**INDEX TO ADMINISTRATIVE RECORD
RELATING TO PROCEEDINGS
HELD BEFORE THE BOARD OF DIRECTORS OF
VENTURA REGIONAL SANITATION DISTRICT
REGARDING THE TOLAND ROAD LANDFILL EXPANSION PROJECT**

Final Environmental Impact Report 2

The Final EIR was prepared in accordance with the Guidelines for the Implementation of CEQA and provides responses to public and agency comments on the September 1995 Draft EIR. The Draft EIR was released for a 45-day public comment period that began on September 21, 1995 and ended on November 6, 1995. In accordance with the California Public Resources Code, Section 2100 et seq., the Draft EIR and the Final EIR together comprise the EIR in its entirety.

FIGURE C.1

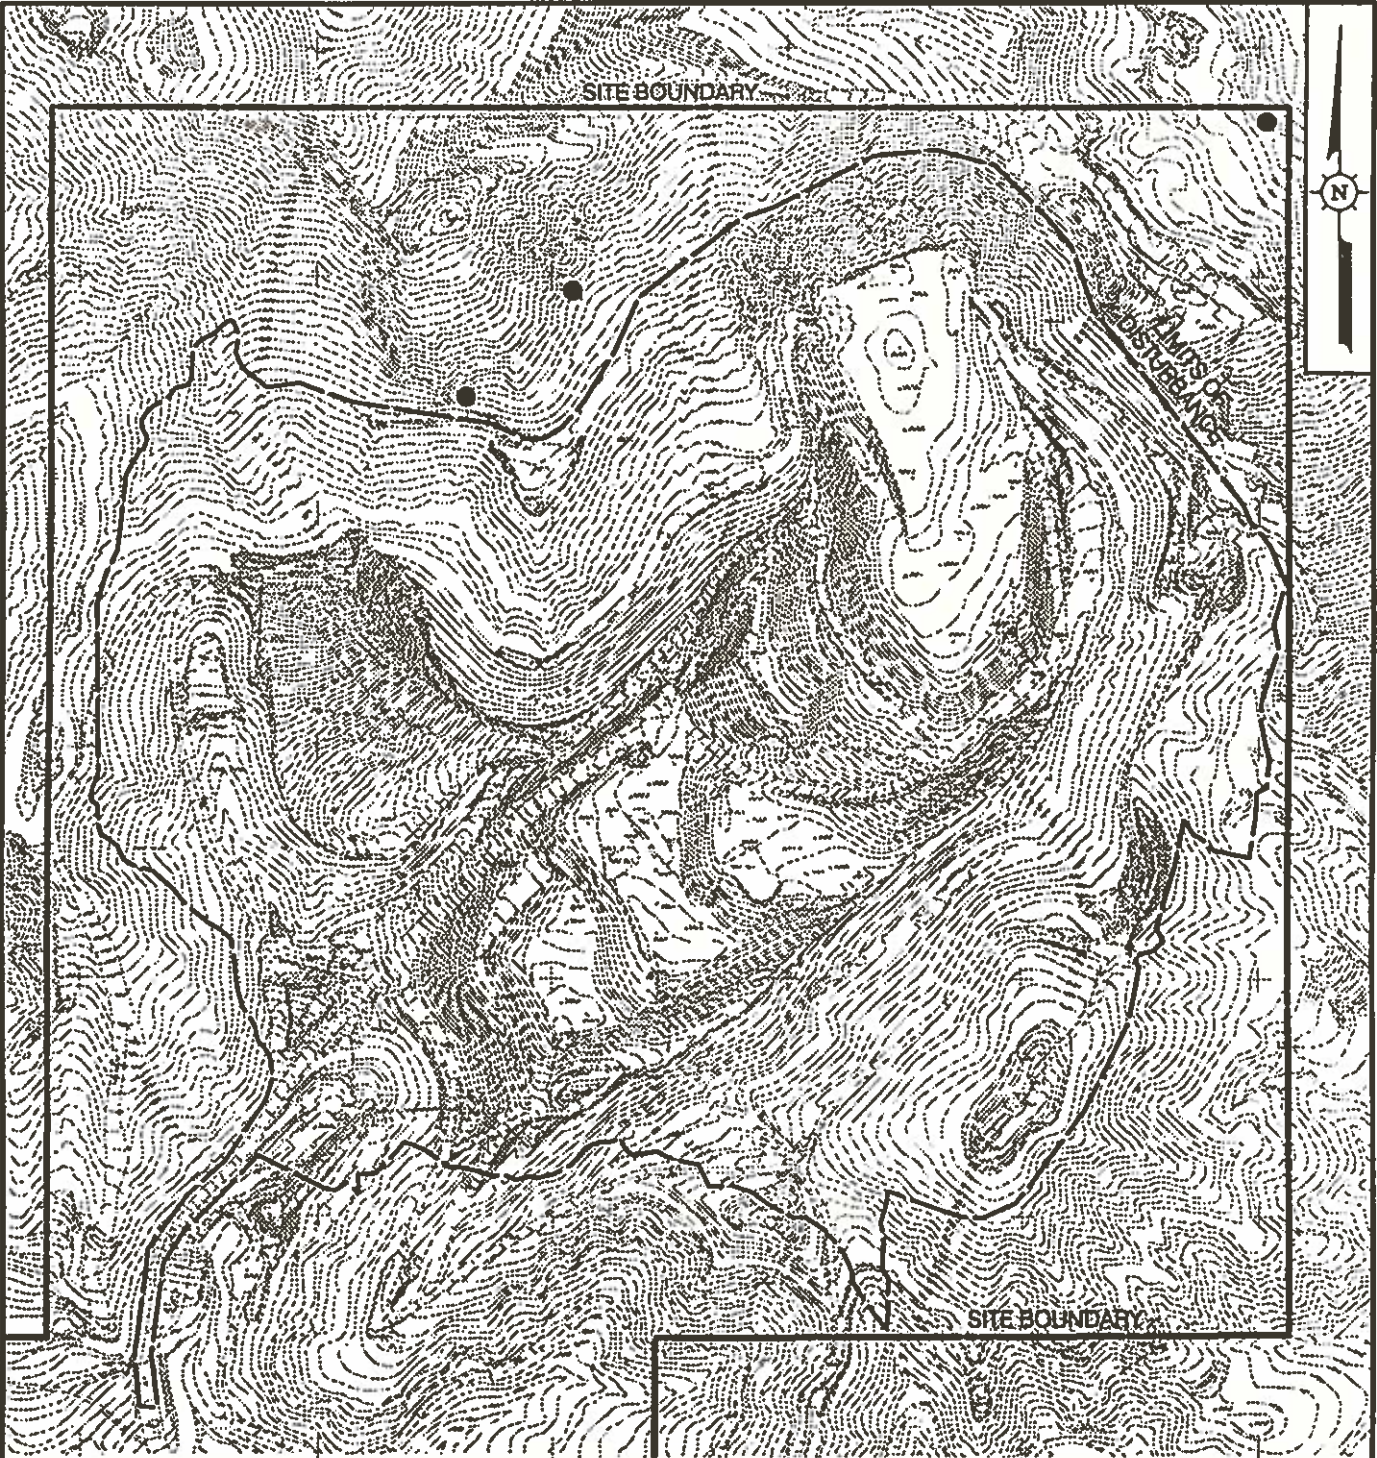
The DEIR indicates that at least one of the seeps on the west of the proposed project will be impacted (Figure 3.4.1 appears to indicate that two seeps would be impacted by the project) and that this will be a significant impact to biological resources. The document further states that O'Leary Creek drainage appears to be a locally important wildlife corridor. The analysis concludes, however, that the proposed project will pose no significant impact to biological resources. Curiously, mitigation measures are offered for implementation. The conclusion of "no significant impact" is unsupported by analysis in the DEIR and, in fact, is contradicted in the discussion.

1. In response to this comment, the locations of the seeps have been placed on a topographic map to clarify their location (see Figure C.1 in Appendix C of this Final EIR).

2. Regarding the second seep that is in close proximity to the limits of disturbance of the proposed project (see Figure 3.4.1), the detailed biological survey conducted for the proposed project determined that this seep and its associated vegetation would not be impacted by the proposed project (Hunt, 1995). While the symbol used to depict seeps in Figure 3.4.1 of the Draft EIR indicates that this seep also extends into the limits of disturbance, this is due to the scale of the figure and the size of the symbol used to depict the seep. The size of the symbol overstates the size of the seep and its associated vegetation. In response to another comment, the seeps have been placed on a topographic map to clarify their location (see Figure C.1 in Appendix C of this Final EIR).
